ITEM: ADOPTION OF A MITIGATED NEGATIVE DECLARATION FOR CIP PW 22-36 AQUIFER STORAGE AND RECOVERY

RECOMMENDATION: Adopt a Resolution Adopting the Mitigated Negative Declaration for the City of Lathrop Aquifer Storage and Recovery Project, CIP PW 22-36 in Accordance with the California Environmental Quality Act Requirements

The City of Lathrop posted the Lathrop Aquifer Storage and Recovery Project Initial Study/Mitigated Negative Declaration (IS/MND) for a 30-day public comment period. The City received several comment letters during the public comment period (August 2, 2023 through September 1, 2023) regarding the project and the environmental analysis.

Figure 2. Site Aerial Map

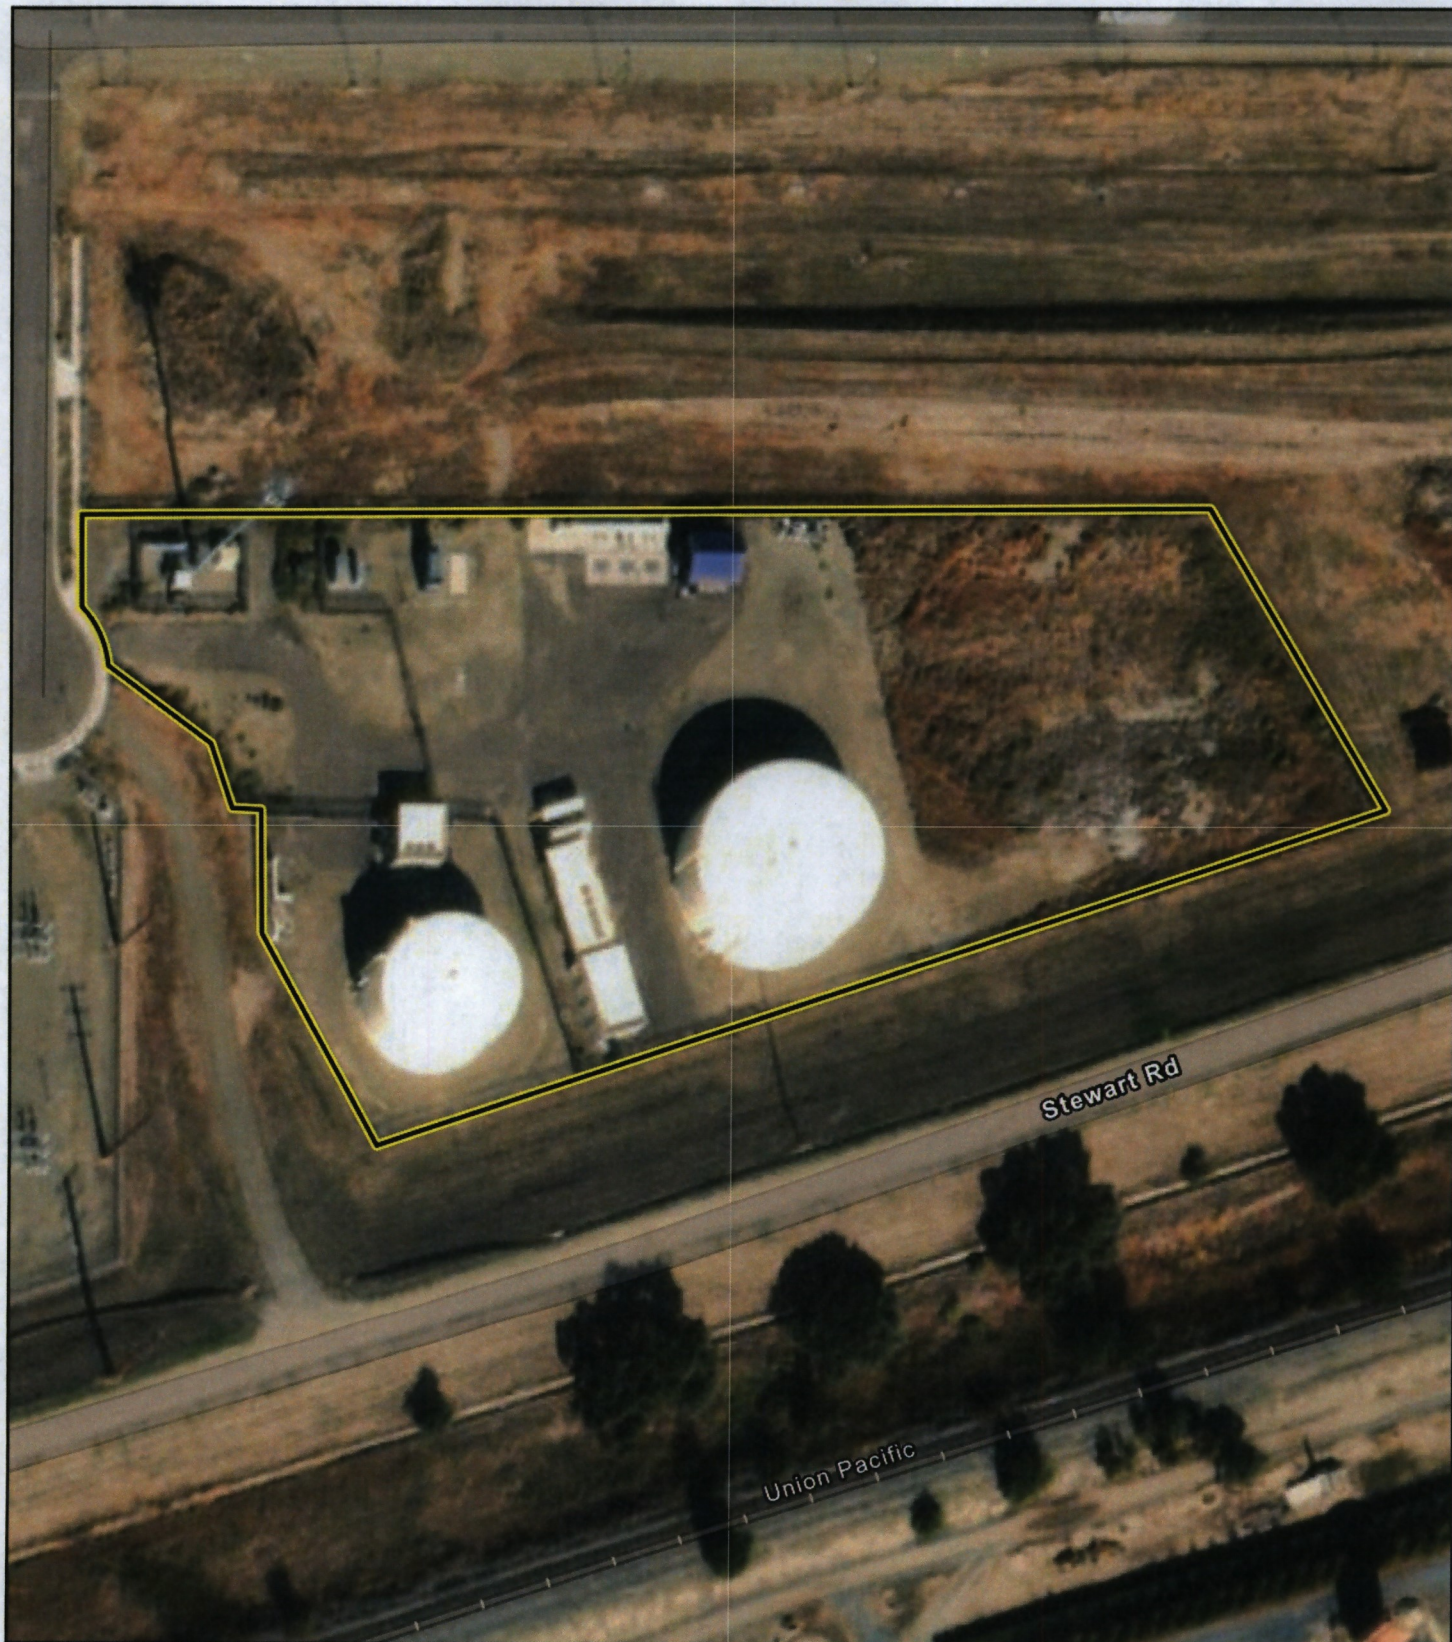
Letter 3 notes that there are two existing tanks shown on the aerial image in Figure 2, in contrast to the IS/MND text on page 5 of the IS/MND that indicates there is only one 1.5-million-gallon (MG) water tank on the project site. While Figure 2 does show two existing tanks within the boundary of the project site, the southwestern most tank, enclosed behind its own fence, is SSJID Water Tank 5. Figure 3 highlights the area to the east of that tank, but still within the project site, and shows one existing tank (the easternmost tank shown in Figure 2) plus two additional tanks to be constructed in the future under a separate proposal. The proposed project does not include the construction of water tanks.
